Item 4.**Development Application: 7-9 Knox Street, Chippendale**

File No.: D/2018/748

Summary**Date of Submission:** 5 July 2018

Amended plans submitted 12 February 2019

Figure 19: West elevation with the 15m height limit plane indicated by the red arrow

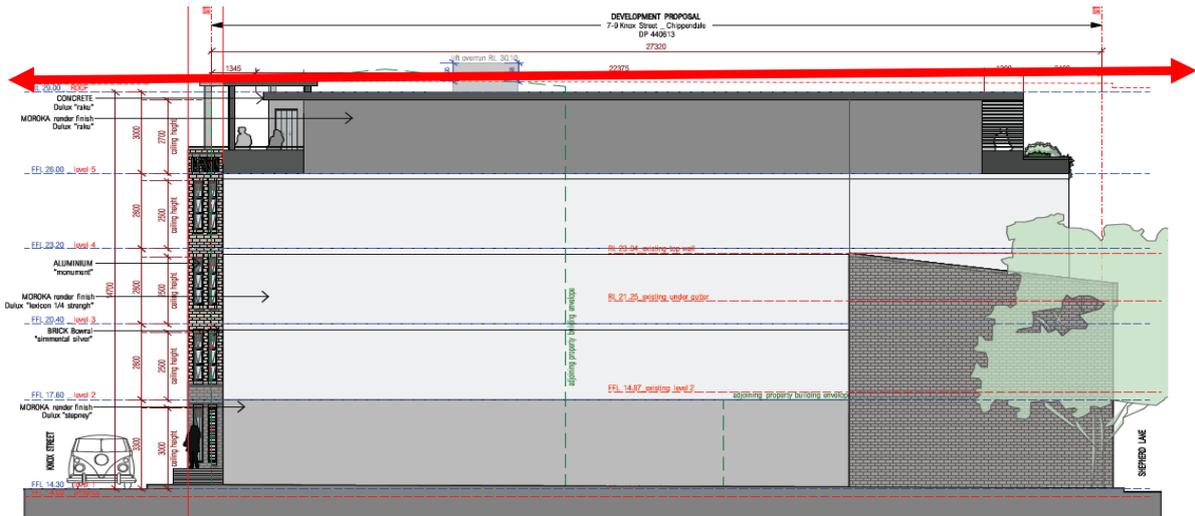
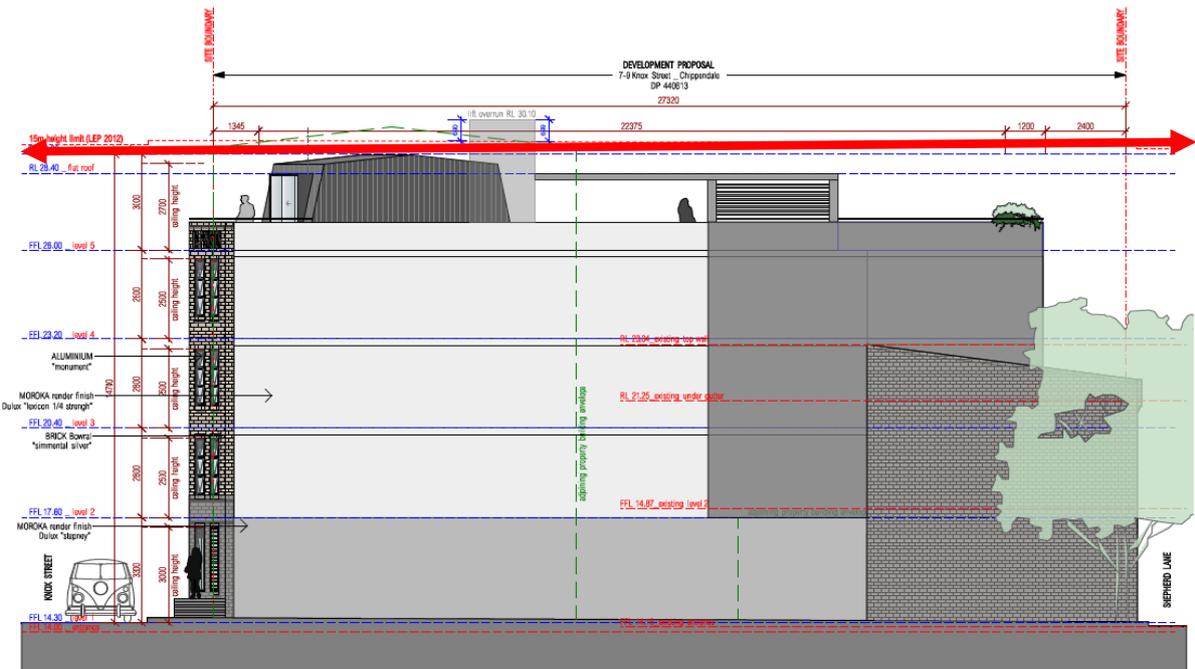
52. The site is subject to a maximum height control of 15m. The proposed development has a height of 15.7m to the lift overrun
53. The variation to the height control results in an exceedance to the development standard by 0.7m (or a 4.5% variation) for the lift overrun. The red arrow in Figure 18 and Figure 19 indicates the 15m height control on the original proposal and amended proposal respectively.

54. During the assessment of the application, concern was raised with the applicant regarding excessive height, bulk and scale, resulting in a built form that is unsympathetic to the heritage conservation area, and will have unreasonable amenity impacts on the neighbouring properties. In response to these concerns, the applicant submitted amended plans detailing the deletion of the fifth storey, deletion of the northern pergola, replaced with smaller attic-like mansard addition accommodating the manager's room. The amended proposal results in all building elements, excepting the lift overrun, sitting within the 15m height plane.

Figure 21: West elevation as amended

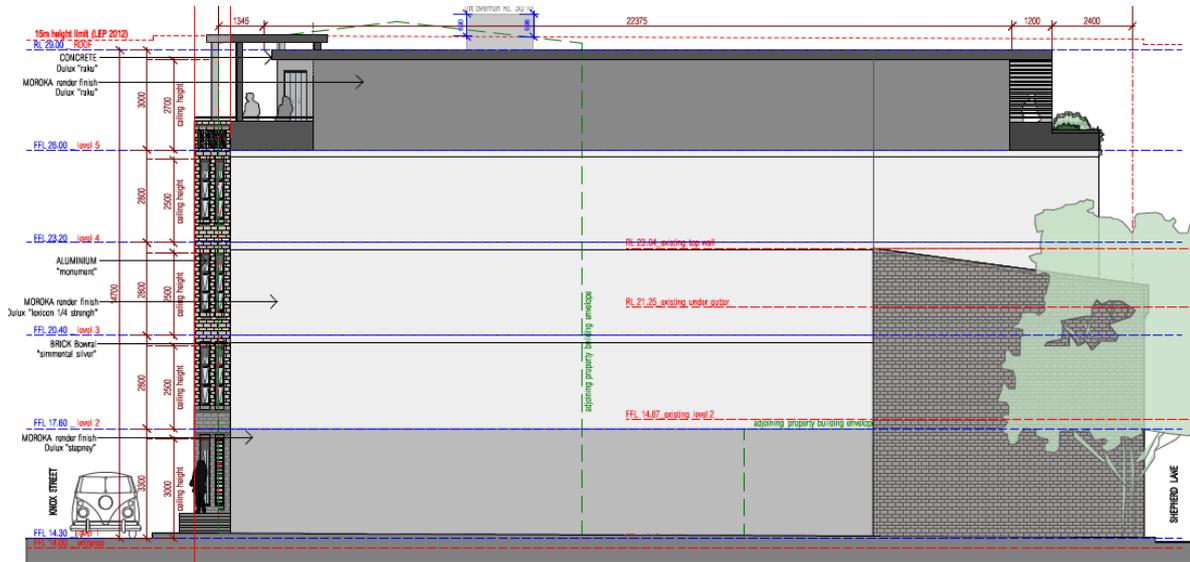
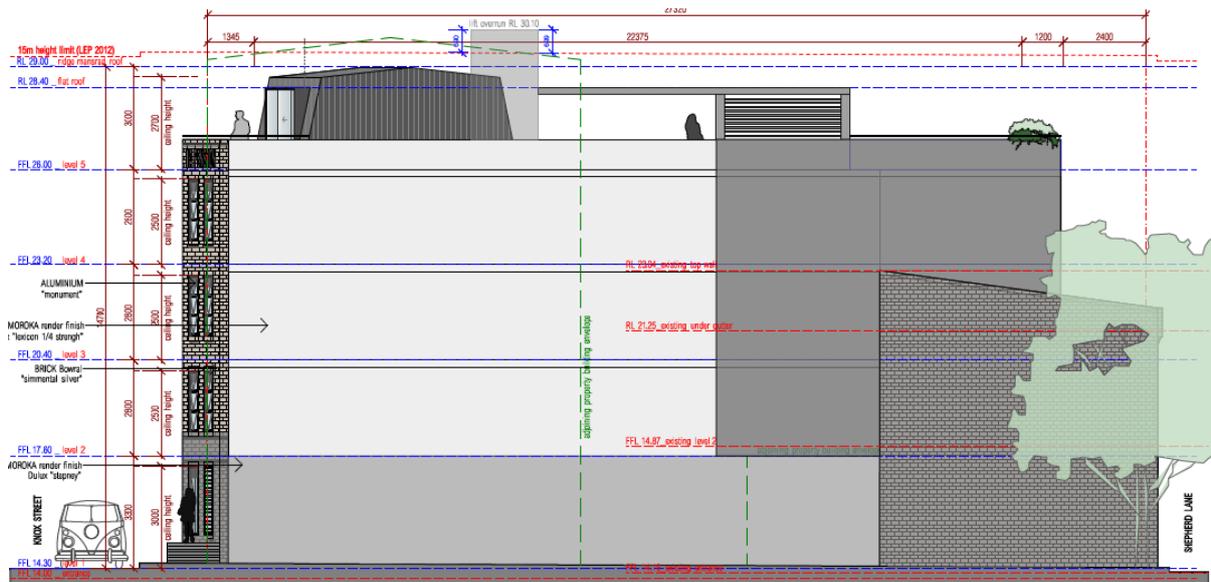
79. In response to these concerns, the applicant submitted amended plans detailing the deletion of the fifth storey, increasing the rear setback of the upper two levels to 2.4m, deleting the bulky pergola structure, and retaining the manager's office at the fifth floor level but incorporating it in an attic-like mansard form. The exceedance of the 15m height control it is limited only to the lift overrun, which is required for accessibility purposes to the roof level communal open space, and is considered acceptable in the context of the proposed development. See further discussion under Clause 4.6.

80. The amended proposal provides an appropriate height transition between the four storey residential flat building to the west and the two to three storey terraces to the east and south. The increased upper level setbacks at the rear and addition of an open courtyard to the east minimise visual bulk. The bulk and scale of the proposal is consistent with the neighbouring properties.

Figure 23: Shadow diagrams submitted with the application showing the extent of additional overshadowing on the terrace row to the south

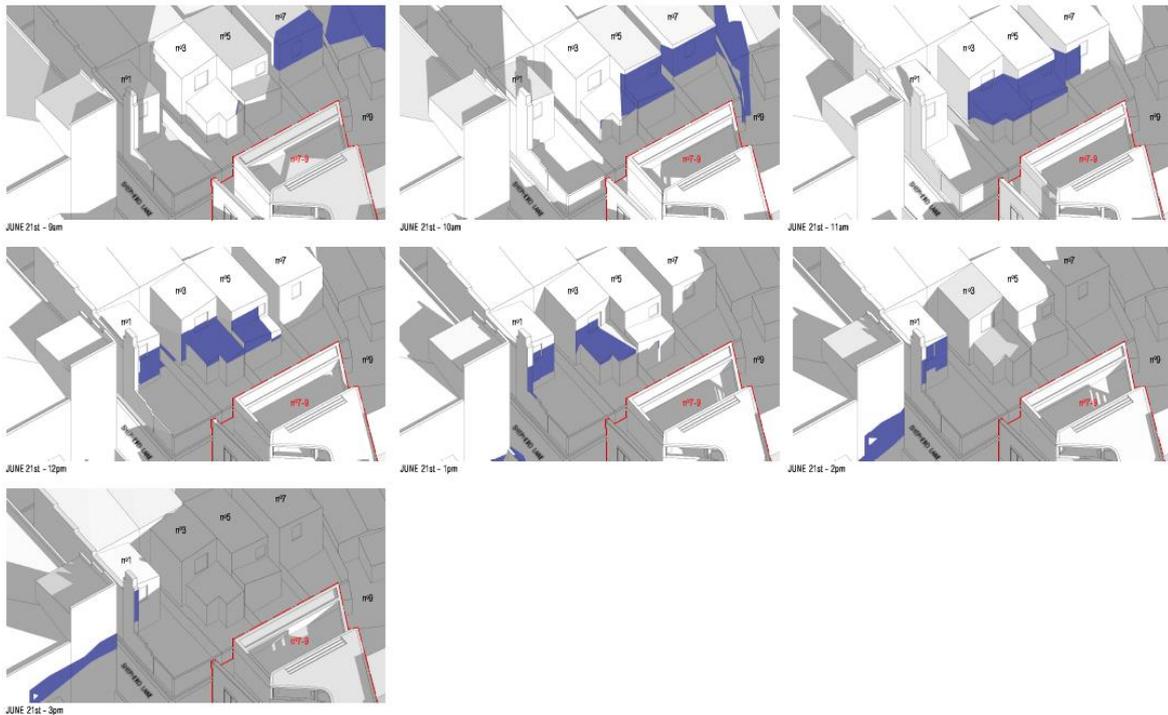
90. The shadow diagrams submitted with the amended application show that the private open space and ground floor windows of 1-9 Rose Street are in shadow throughout the day between 9.00am and 3.00pm on 21 June. Direct solar access is provided throughout the morning on 22 September.

91. The shadow diagrams show additional overshadowing to the first floors and roofs of each of the five properties between 1 and 9 Rose Street on 21 June.

97. The shadow diagrams show additional overshadowing to the rear of 21-22A, 23 and 25 Shepherd Street at 3.00pm, however, solar access is maintained between 9.00am and 12.00 noon. The shadow diagrams show the west-facing windows of the site at 21-22A Shepherd Street are overshadowed throughout the day.

98. The amended proposal has adequately demonstrated compliance with DCP provisions. The proposal is acceptable in regard to solar access.

Figure 24: Sun diagrams illustrating solar access to communal open space

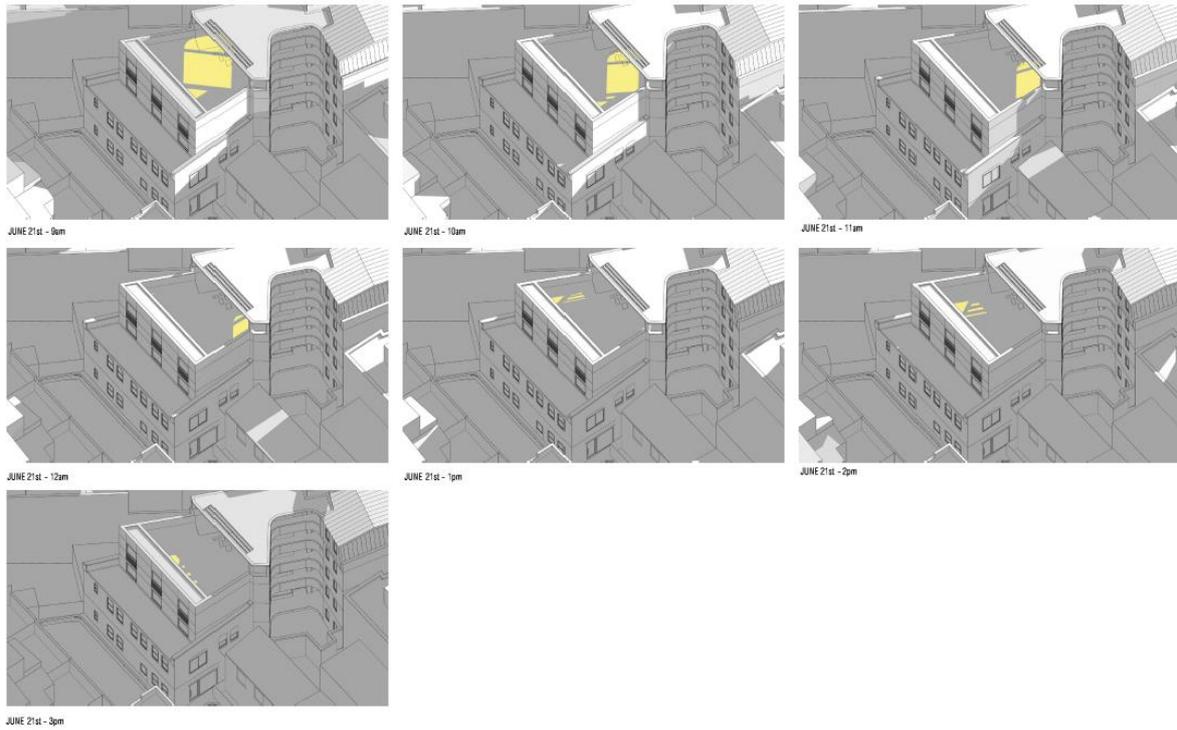
100. Figure 24 shows the solar access achieved to the communal open space on the roof. It shows that direct sunlight is achieved throughout the day, but for less than 50% of its area (except in the morning). Figure 25 shows that no direct sunlight is provided to the communal living room or the outdoor communal courtyard at ground level. The non-compliances are considered acceptable in this instance given the site constraints and the communal areas being in the most appropriate locations.

101. The original proposal relied upon the site's existing central courtyard for the provision of communal open space at the ground floor. Concern was raised with the applicant that the communal open space did not meet solar access requirements, and in response, the primary communal open space was relocated to the roof. This is considered an improved design and amenity outcome.

Figure 26: The proposed demolition plan showing the location of the trees to be removed

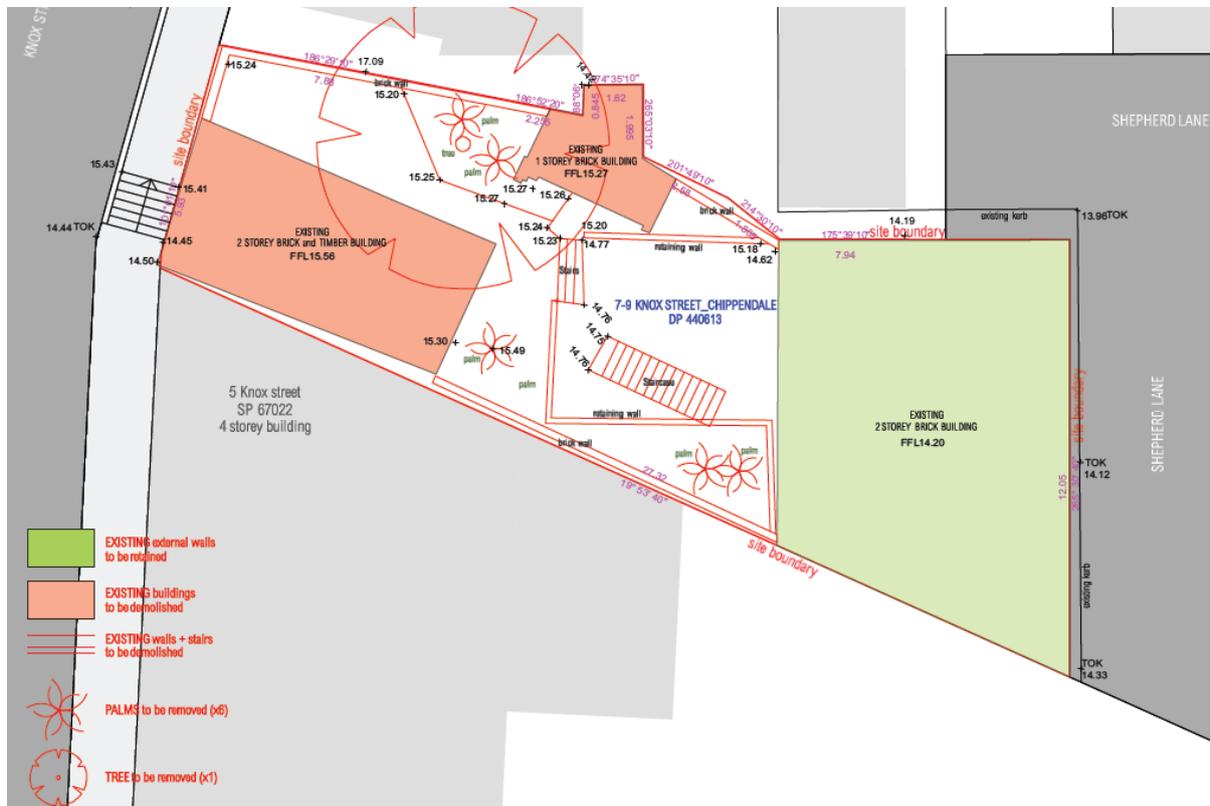
112. In response to the above concerns, the applicant provided an approved tree permit application from August 2012 (2012/241899) which was purportedly for the removal of the Gum tree citing inappropriate location as the reason for its removal. It is not clear if the tree that was approved to be removed is the Gum tree in question as there have reportedly been similar trees on the site previously.

113. Notwithstanding the Tree Management Officer's concerns, a tree replacement condition is recommended in the event of an approval. As a result, the applicant will be required to provide a minimum of 15% canopy coverage, to be provided by a tree species that will reach a minimum of 10m in height upon maturity. The removal of the small palm trees will also be permitted as they are located within the development footprint.
